87C196KT Microcontroller

Specification Update

November, 1998

Order Number: [272862-004](#)

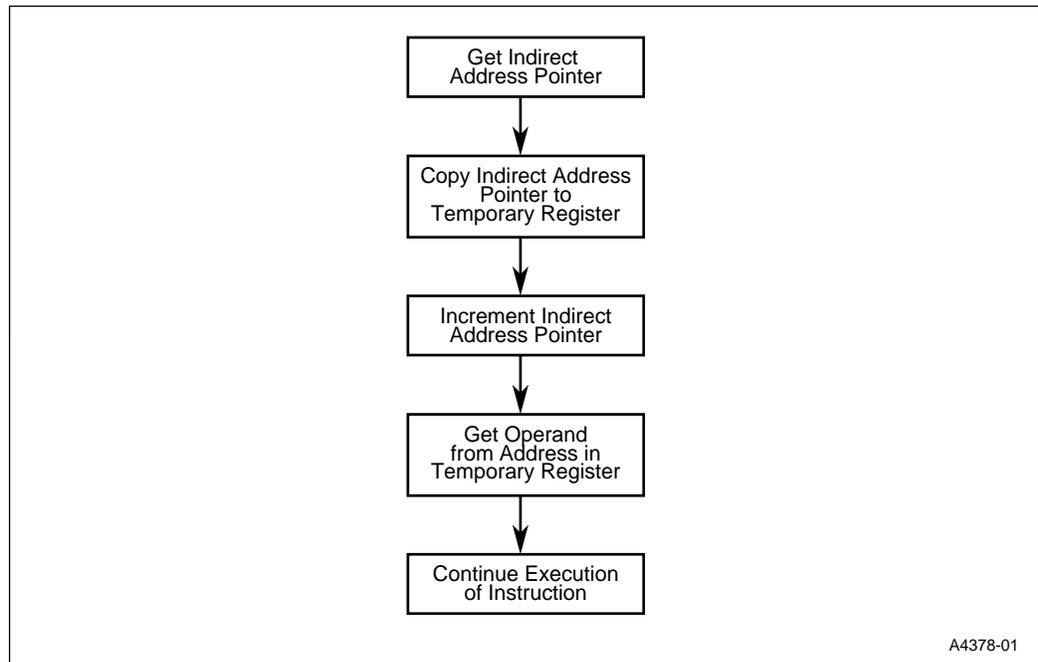
- Check for pending EPAX interrupts before exiting an EPAX ISR

Another method for avoiding this situation is to check for pending EPA interrupts before exiting the EPA interrupt service routine. This is an easy way to detect overruns and additional interrupts. It can also save loop time by eliminating the latency necessary to service the pending interrupt. However, this method cannot be used with the peripheral transaction server (PTS).

Figure 1. 16-bit System with EPROM

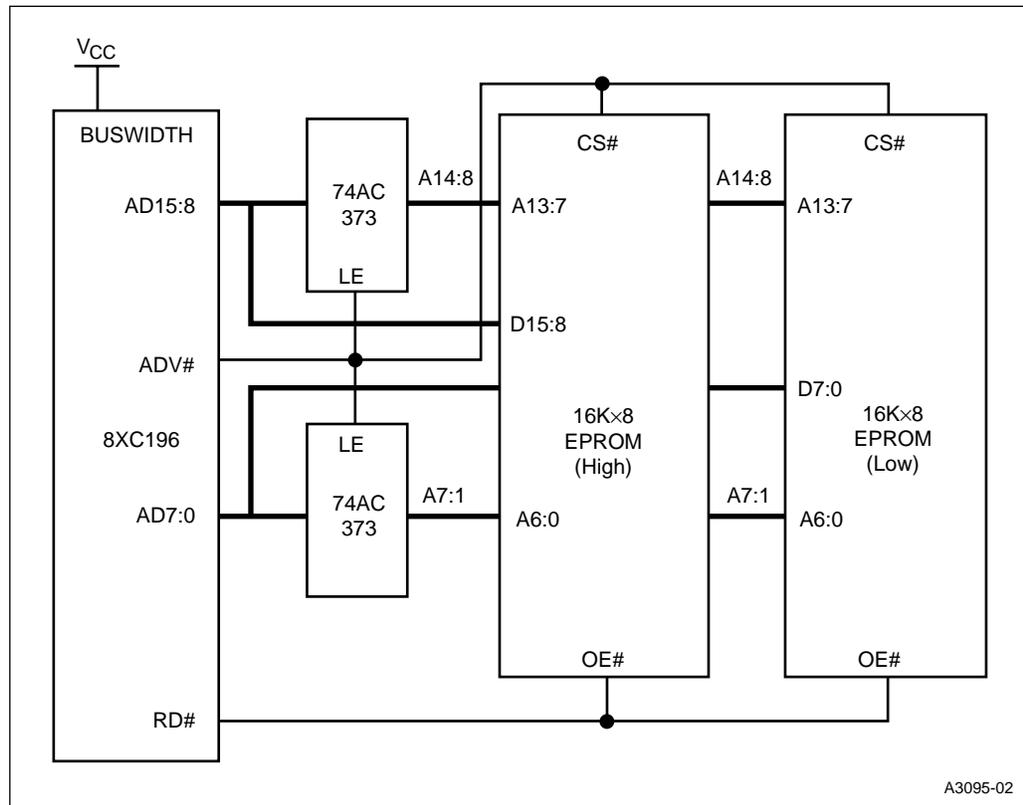
1. High address inputs to the low EPROM should be A14:8

Issue: In the *87C196Kx, 8XC196Jx, 87C196CA Microcontroller Family User's Manual*, the block diagram for a 16-bit system with EPROM incorrectly listed the high address inputs to the low EPROM as A15:8. The correct inputs are A14:8, as reflected in the following figure:
